**REGULAR MEETING OF THE
CITY OF ALVARADO PLANNING AND ZONING COMMISSION
104 W. COLLEGE AVE.
MAY 16, 2024
6:30 PM
AGENDA**

This letter is to inform you that the attached Lone Oak Addition Phase 1 final plat application provided on April 22, 2024 has generated the recommendation of disapproval from the Alvarado Planning and Zoning Commission due to the following comments not being adequately addressed to result in compliance with the Alvarado subdivision ordinance.

ENGINEERING PLANS
FOR
LONE OAK PHASE 1
CITY OF ALVARADO
JOHNSON COUNTY, TEXAS
MARCH 2024

City Engineer Remarks on Preliminary Plat and Preliminary Engineering

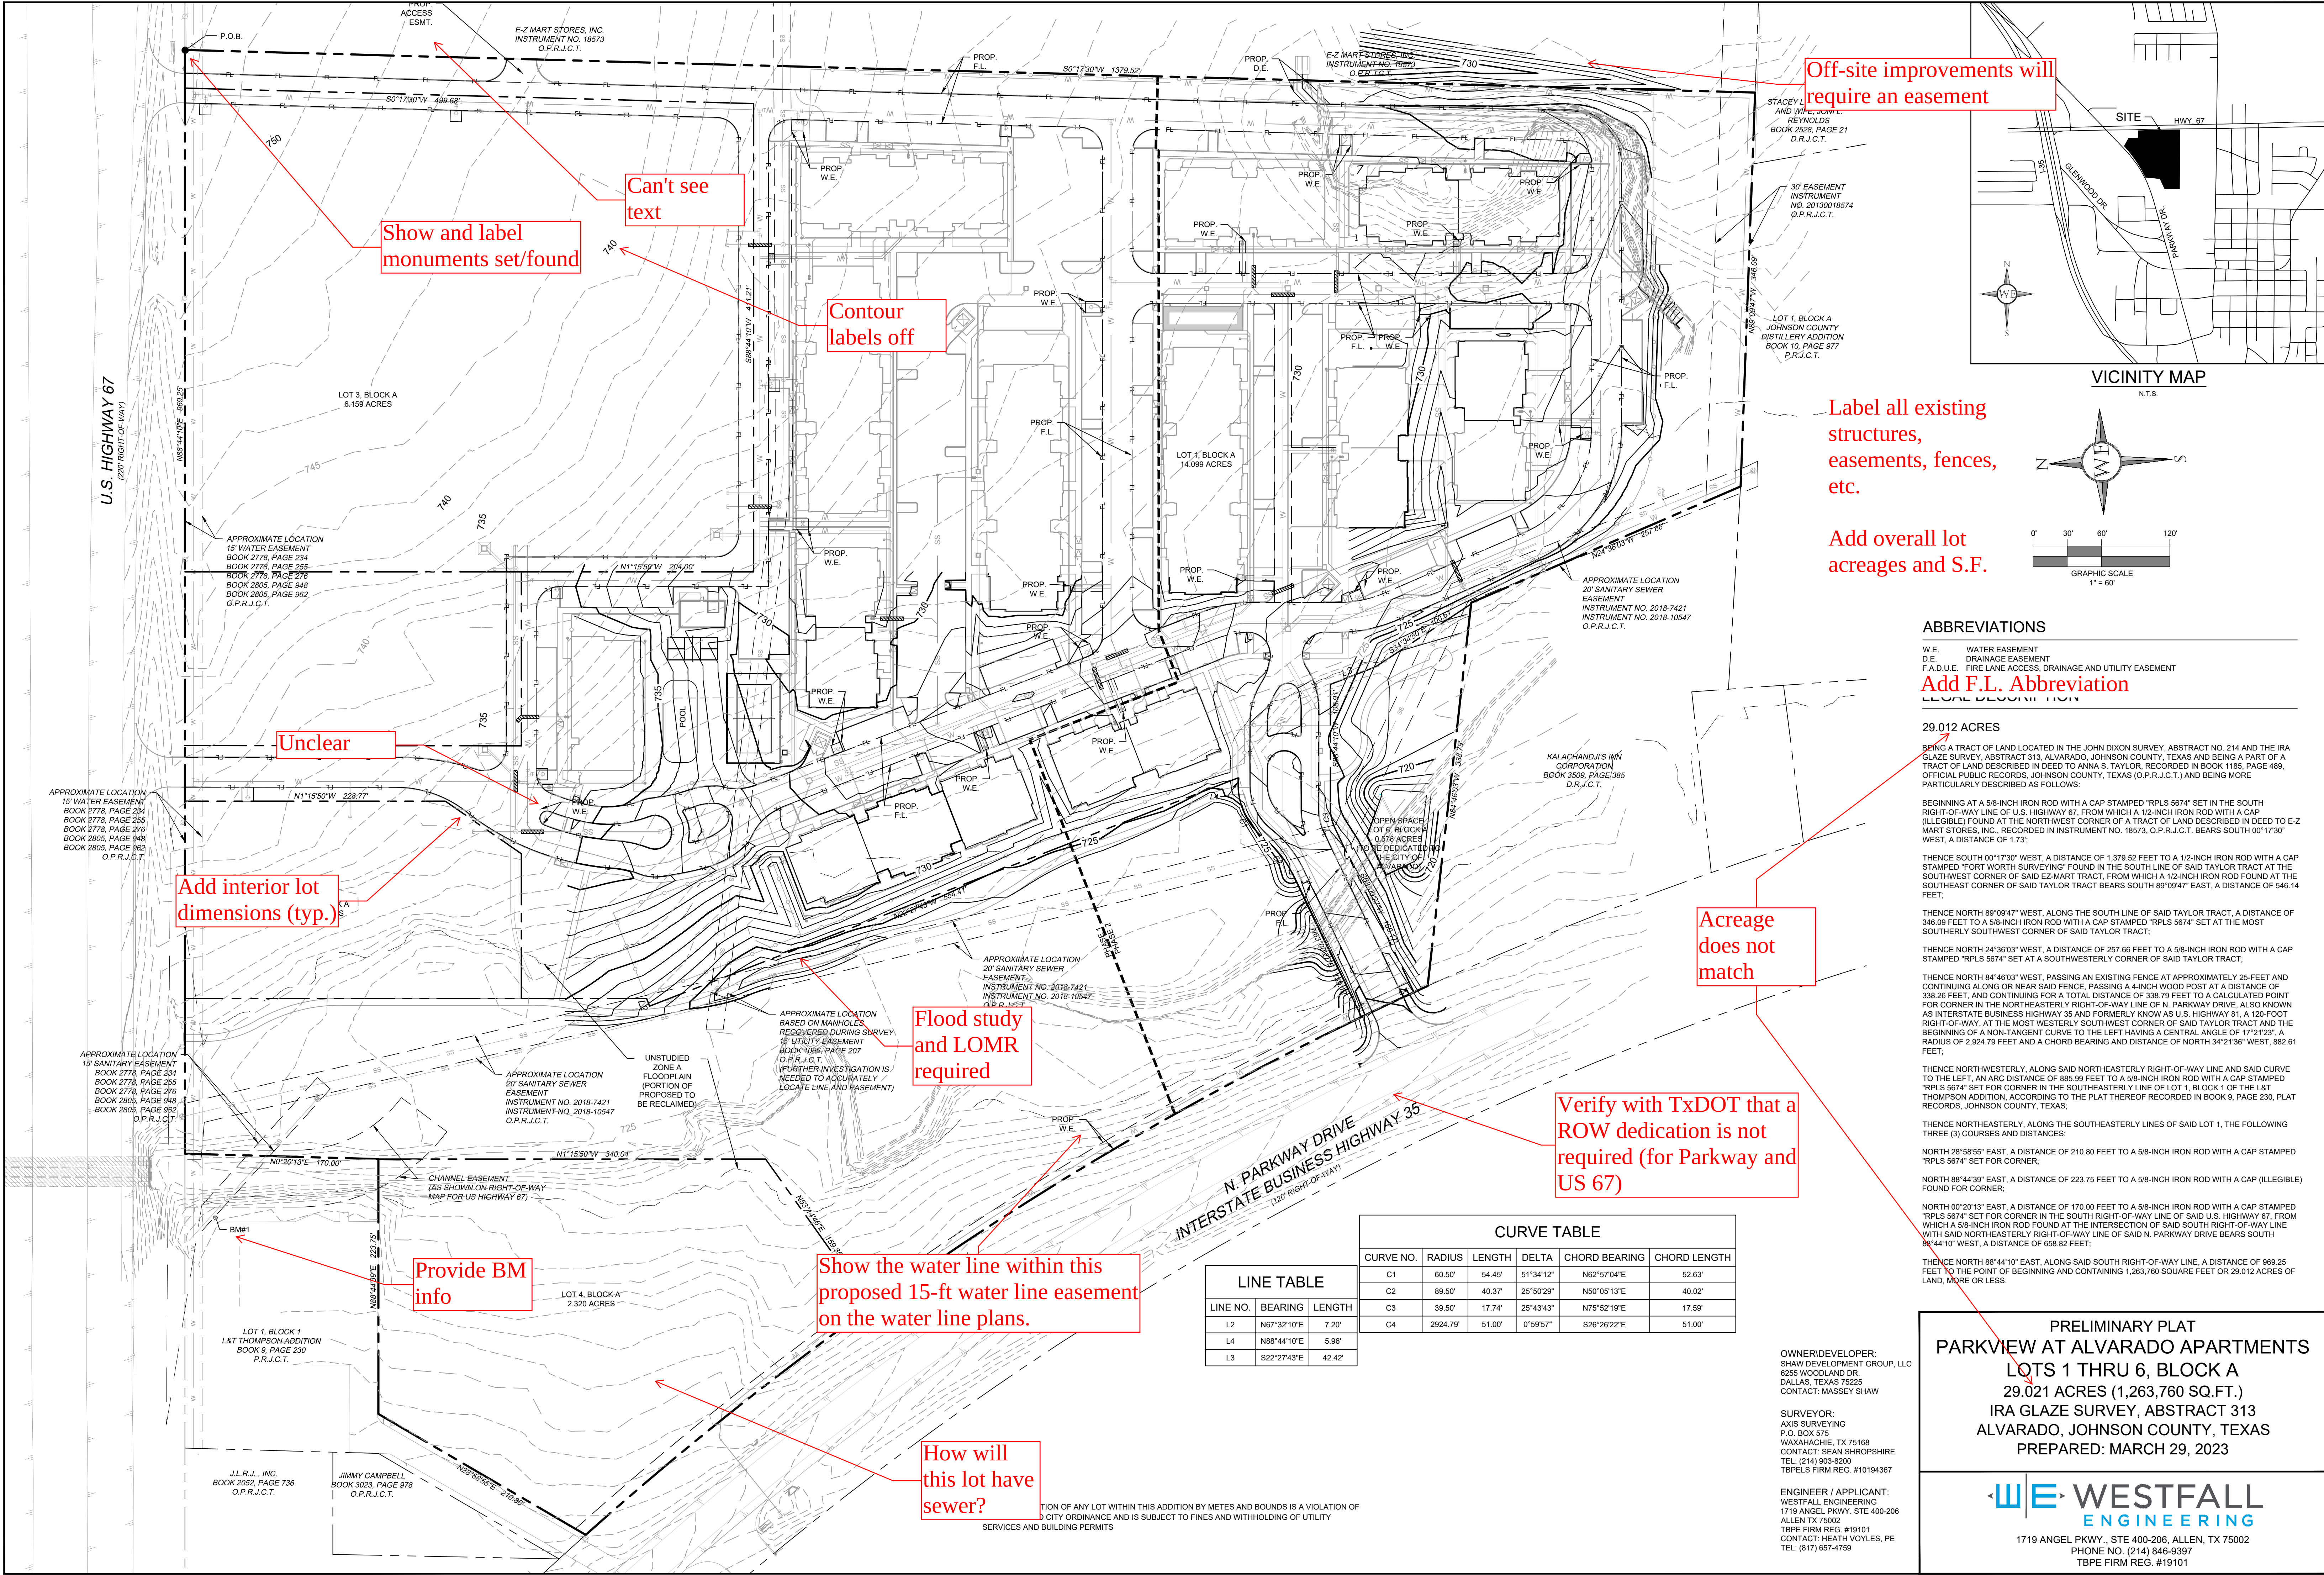
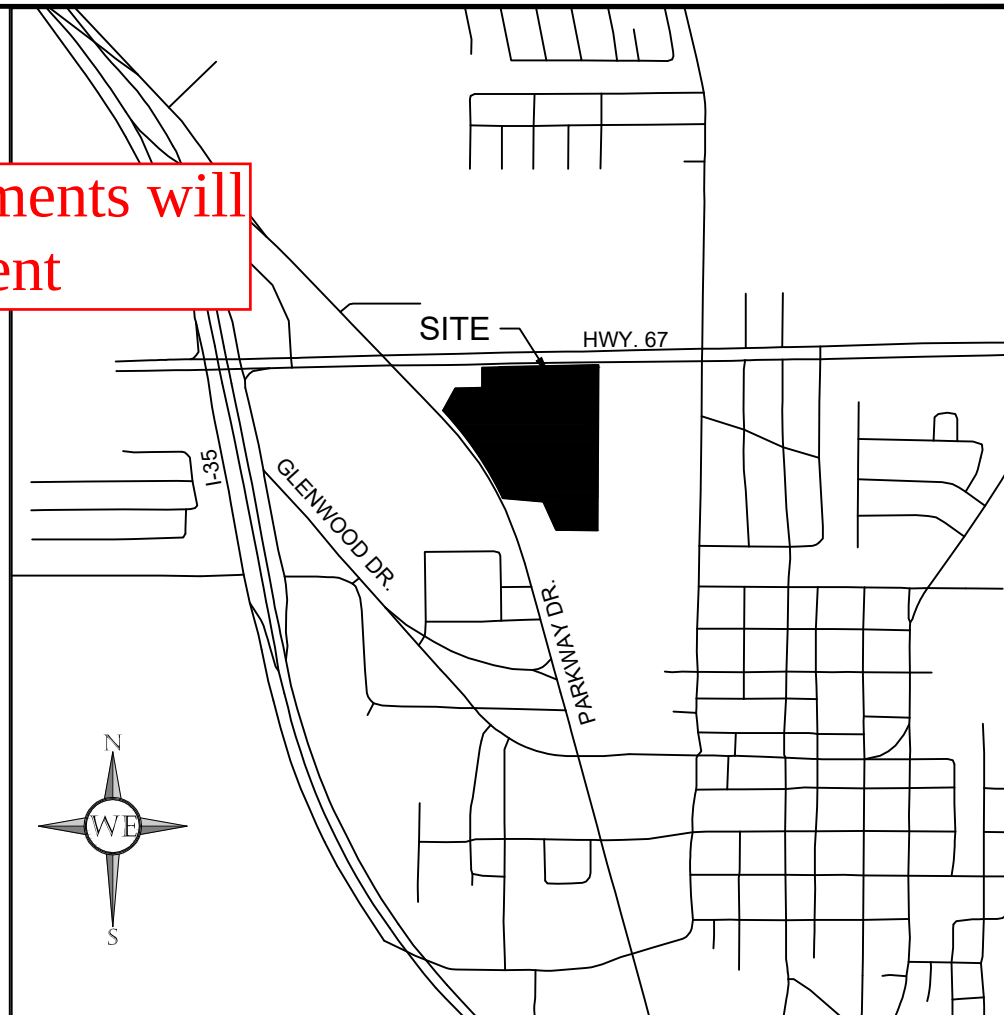
Acreage does not match

Flood study and LOMR required

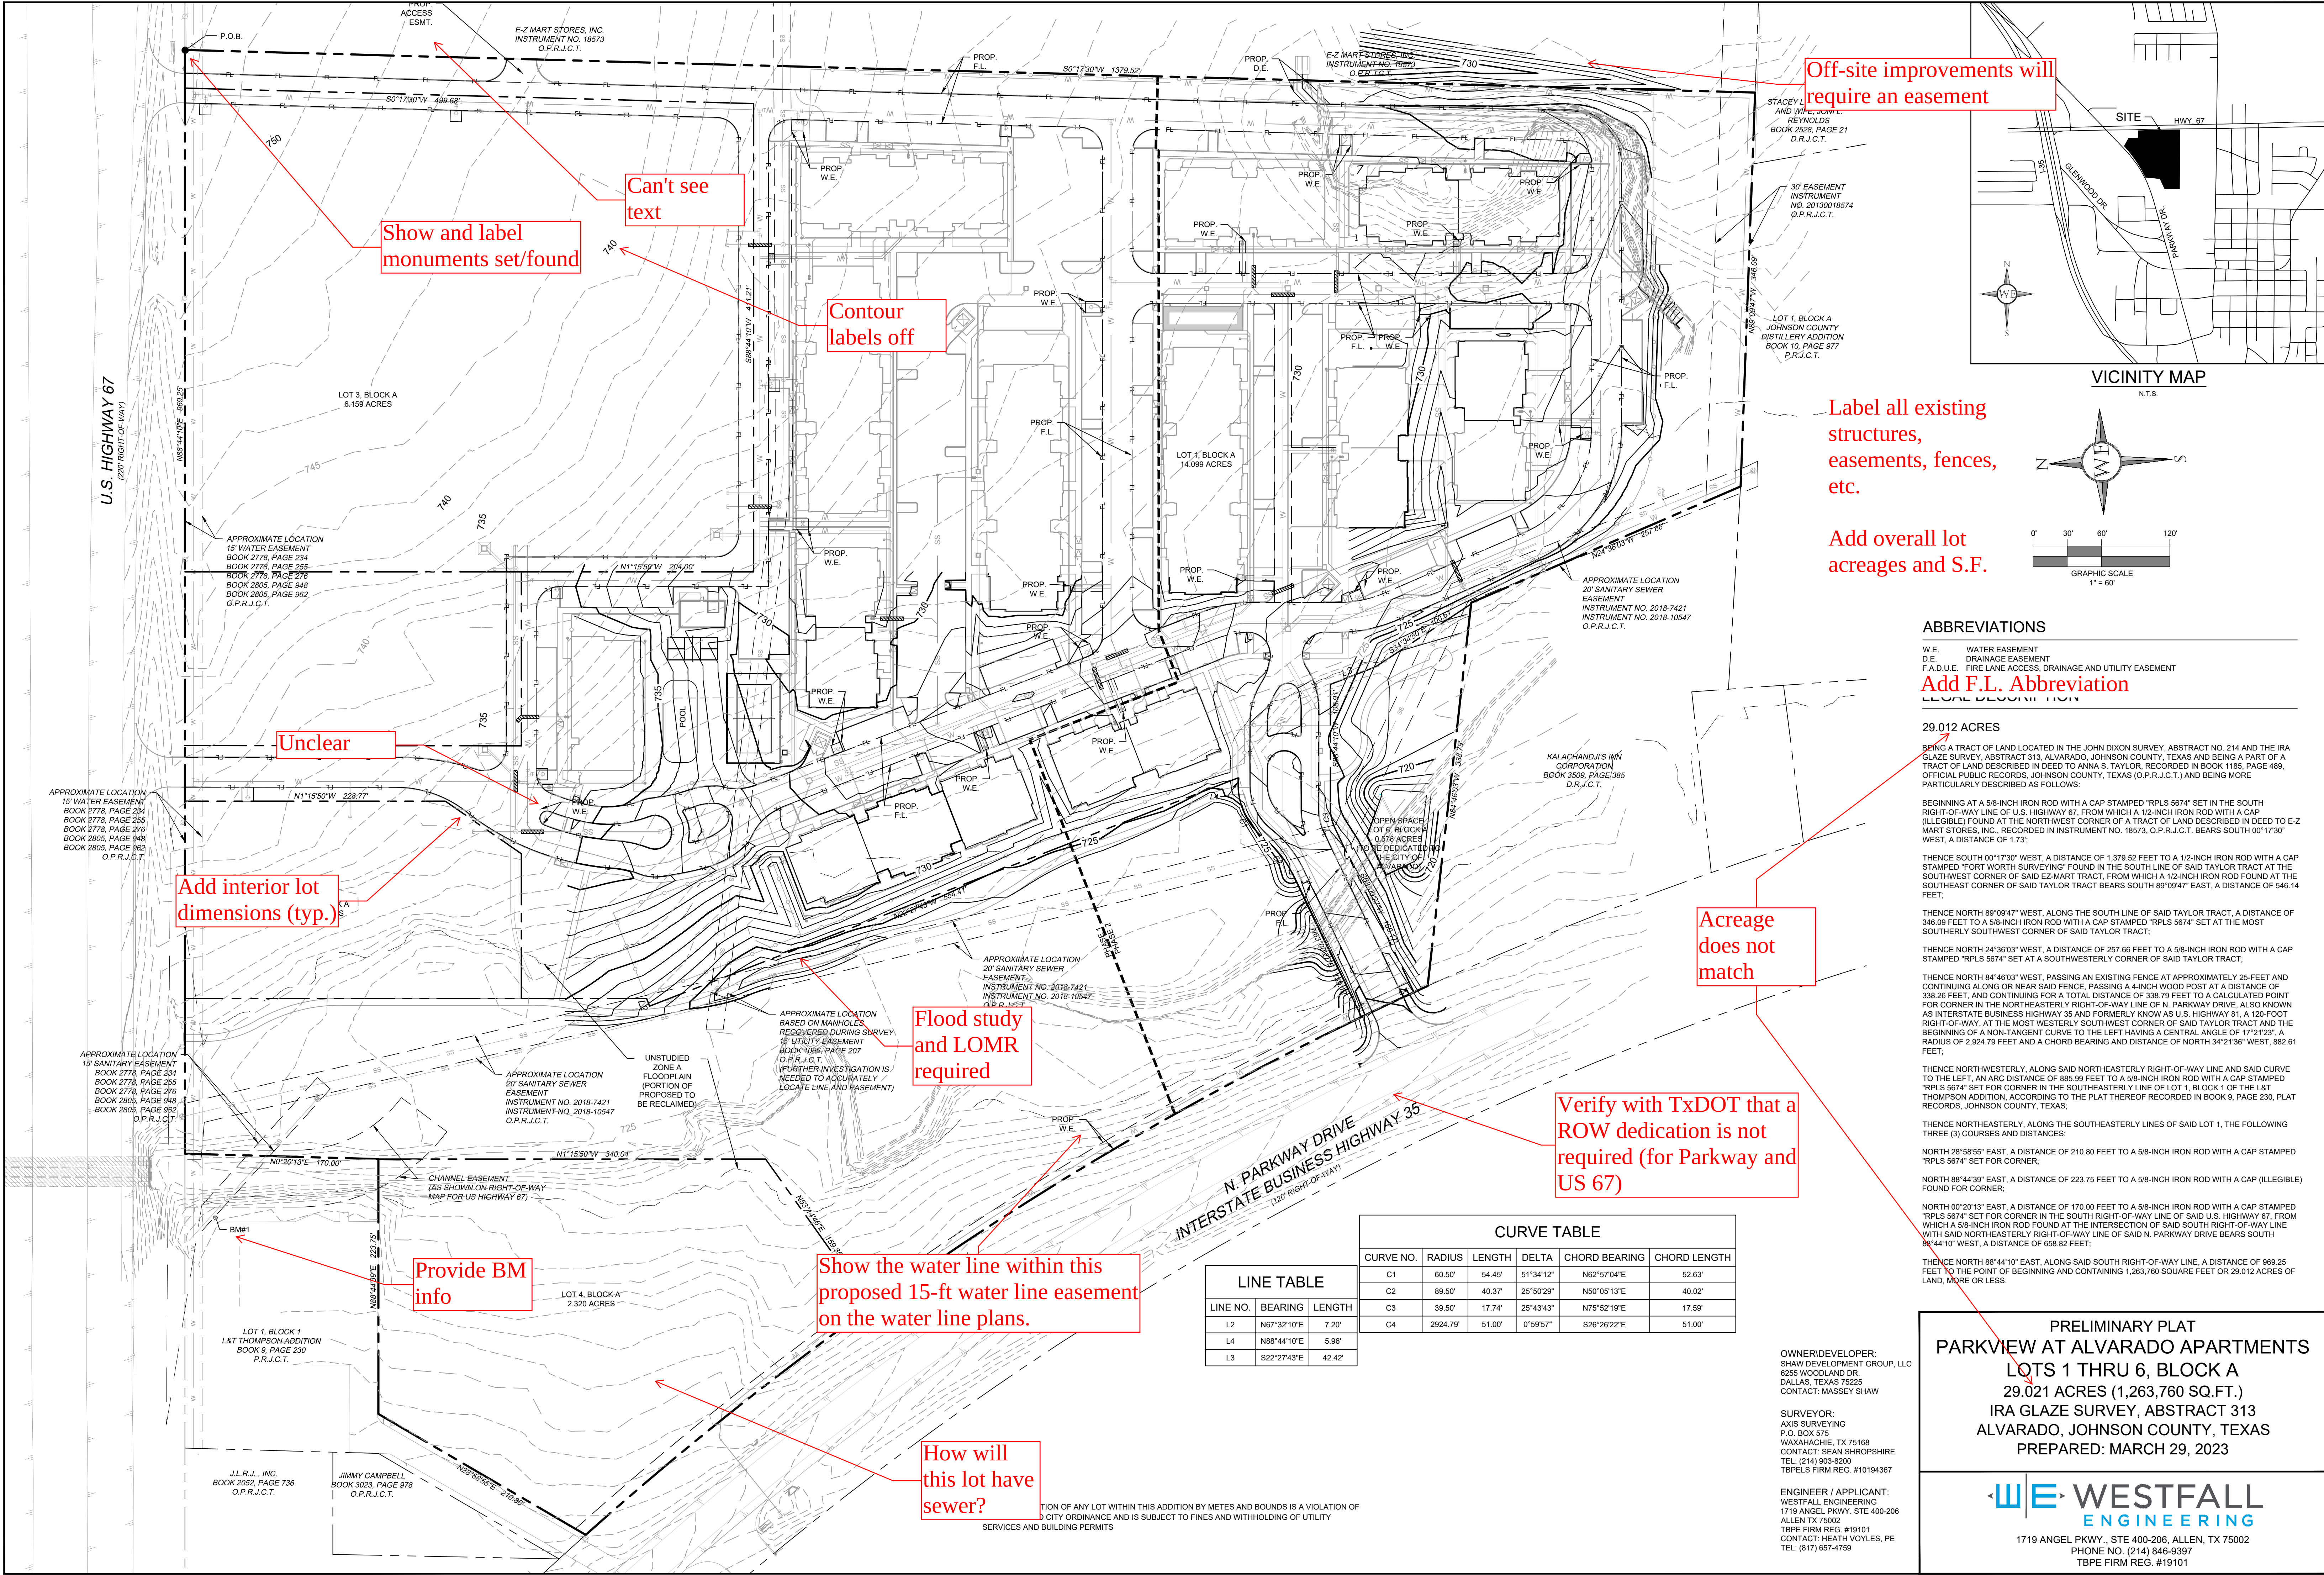
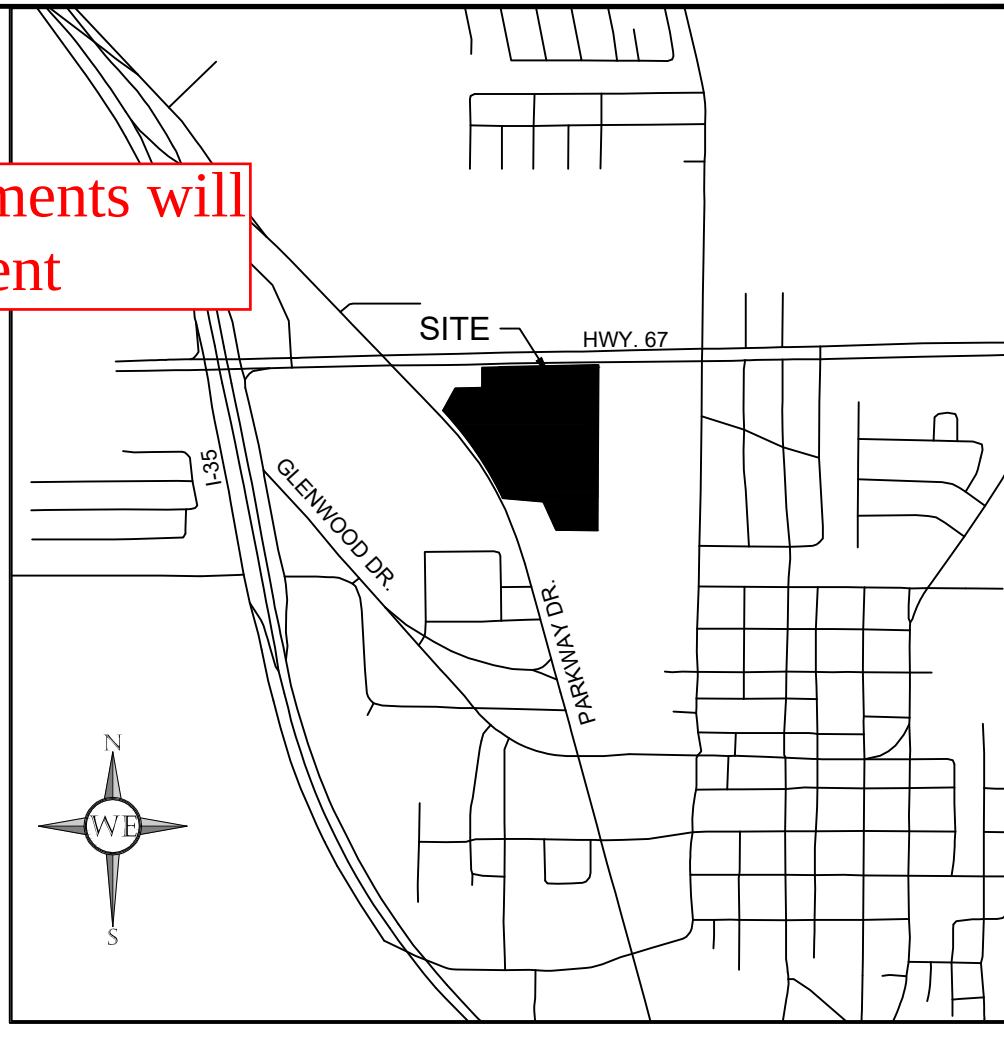
Off-site improvements will require an easement

Acreage does not match

Flood study and LOMR required
